ISLAND AVENUE:
109B-C-7-8

CLIFF ISLAND

Subject: Application for building permit to make
alterations in and change the cottage of Leland
Merrill on Island Avenue, Cliff Island (Assessors
Lot No. 1095-C-8,7) to a year-round dwelling

Subject: Application for building permit to
make alterations in the cottage owned by
Leland Merrill, Island Avenue, Cliff Island,
and conversion of the cottage to a year-
round dwelling for one family.

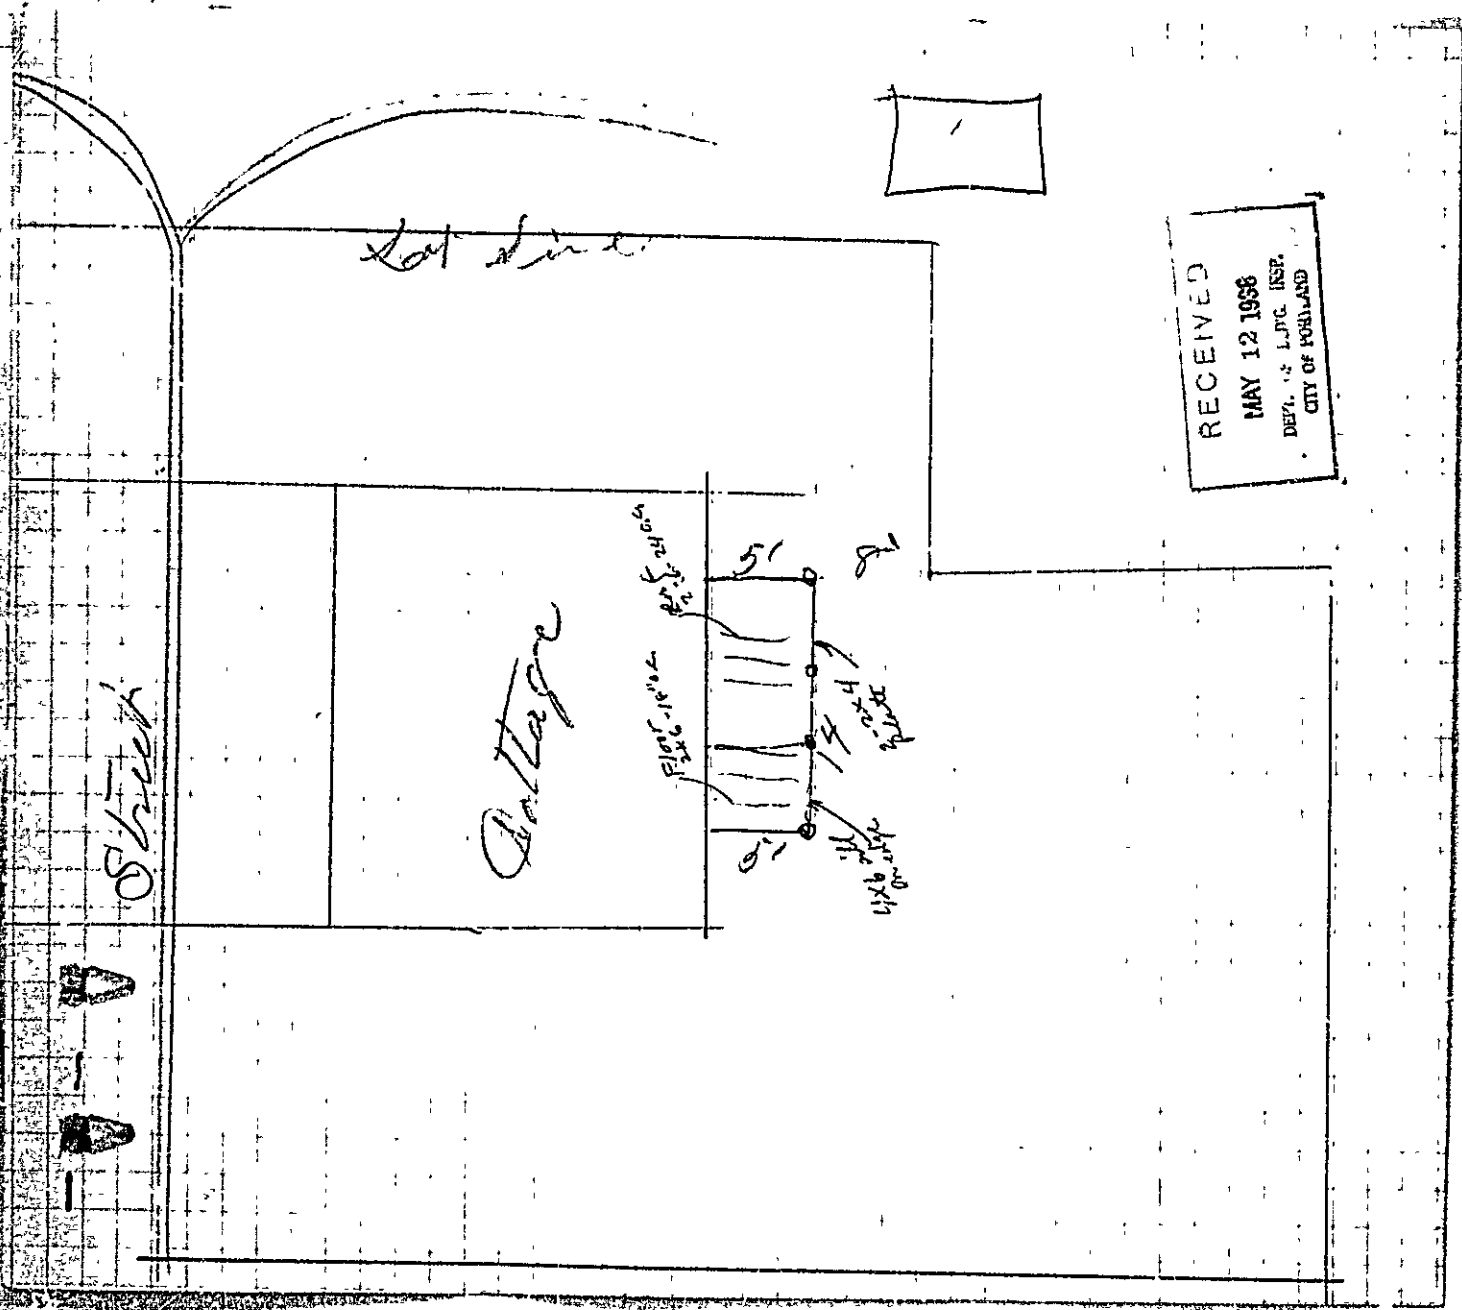
You have a distance of eight feet from the proposed new work to the nearest rear property line. If it should turn out that this distance is less than eight feet you should refrain from starting the work and return the permit to this office at once, as the work would then be illegal under the Zoning Ordinance, and could be legally done only by successful appeal to the municipal officers.

There is insufficient information in your application for me to make sure that the framing will comply with the Building Code. For instance, no location of foundation posts is shown so I cannot tell what spans the 4x6 sills will be on or how much of a load they will be called upon to carry. There is nothing to show the size of the member to support the eave ends of the roof joists, or the span of it.

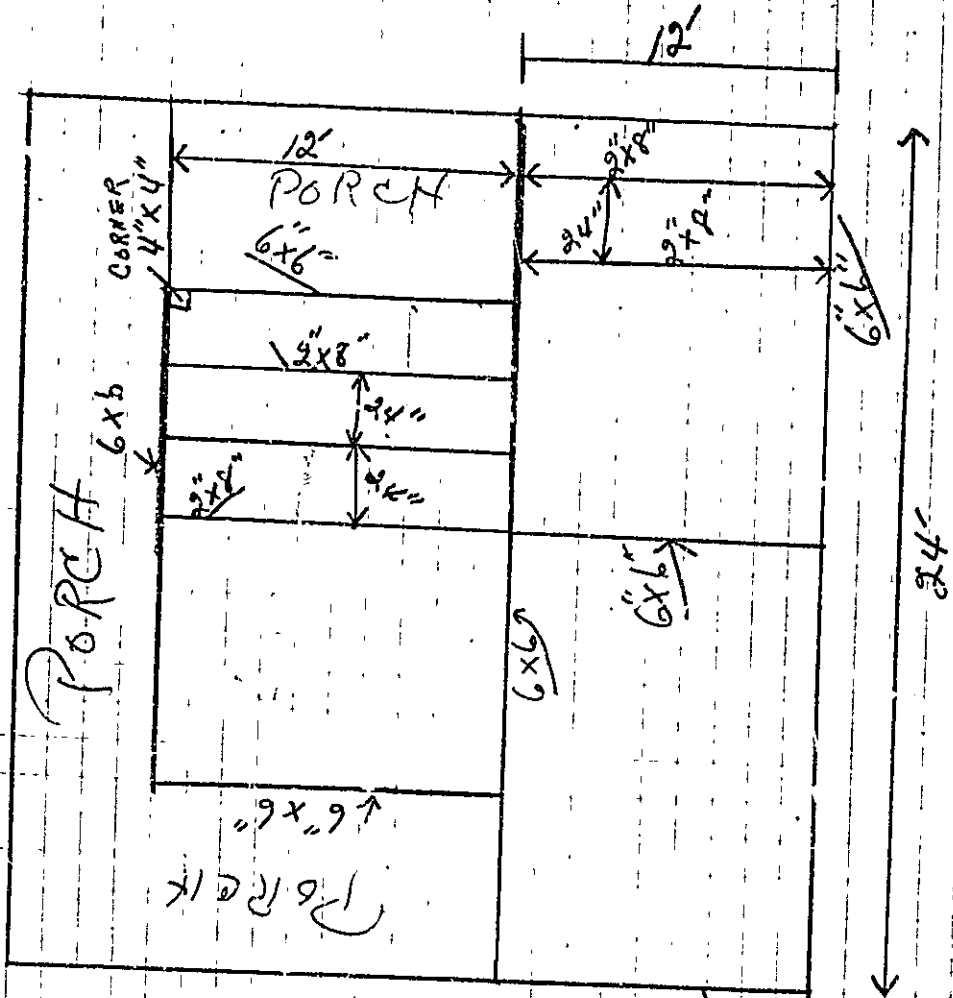
Plan file 1 Nov. 15 your cottage as
no. 24' wide. The framing plan filed by
Mr. Wickerson gives it 30' (scaling)

Plan filed gives outside wall studs 2x4-20" apart which would be 24" O.C. Sect. 312c.3.6 limits this spacing to 16" O.C. except cottages for summer use only. ^{bearing partition spacing not given.} Corner posts given as 4x4 with regular 3x2x4 at least.

Plan shows what appears to be the main girder as 6x6 on 12" span (for winter support shown) this will carry 1st floor, partition, and part of second floor, and is obviously ^{sup}overlaid as a 6x6 on 12" span is good for 16.95#

First floor is 2x8-24" O.C. 12" span good for 9.31

outside studs
 are 2x4"
 approx. 20" apart
